# Access Compliance Report

## Public Rights-of-Way

Intersection ID: 10020348	Main Street: BALLANTYNE COMMONS PY	Cross Street: N/A	Location: SW
ADA ID: B10E71A596C6	Ramp Type: Perp	Initial Pass/Fail: Fail	Overall Compliance: No
Severity Score: 30			
Codes/Mitigation Info/Possible Solution		Field Measurements/Component Compliance

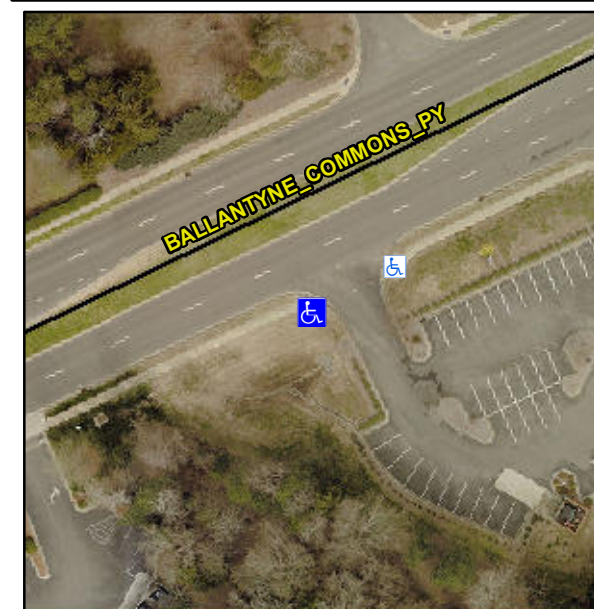
**Not Found, R304.5.1, R304.5.3**

Compliance	Description	Data	Compliance	Description	Data
N/A	Ramp Length (in)	108.0	Yes	Ramp Slope (%)	7.5
No	Ramp Width (in)	34.0	No	Ramp XSlope (%)	6.5
N/A	Flare Type LT	N/A	N/A	Flare Type RT	N/A
N/A	Flare Slope LT (%)	N/A	N/A	Flare Slope RT (%)	N/A
N/A	Flare Traversable LT?	N/A	N/A	Flare Traversable RT?	N/A
N/A	Landing Length (in)	N/A	N/A	DWS Provided?	N/A
N/A	Landing Width (in)	N/A	N/A	DWS Contrast?	N/A
N/A	Landing Slope (%)	N/A	N/A	DWS Length (in)	N/A
N/A	Landing X Slope (%)	N/A	N/A	DWS Full Width?	N/A
N/A	Landing Curb? (Y/N)	N/A	N/A	DWS Offset (in)	N/A
N/A	Shared Landing?	N/A			
N/A	Gutter Ponding?	N/A	N/A	Gutter Slope (%)	N/A
N/A	Gutter Lip Ht (in)	N/A	N/A	Gutter X Slope (%)	N/A
N/A	Painted X Walk1?	No	N/A	Painted X Walk2?	N/A
	X Walk 1 Direction	To E		X Walk 2 Direction	N/A
N/A	X Walk 1 Width (in)	N/A	N/A	X Walk 2 Width (in)	N/A
	X Walk 1 Slope (%)	4.5		X Walk 2 Slope (%)	N/A
	X Walk 1 X Slope (%)	2.0		X Walk 2 X Slope (%)	N/A

**Remove & Replace Entire Ramp.**
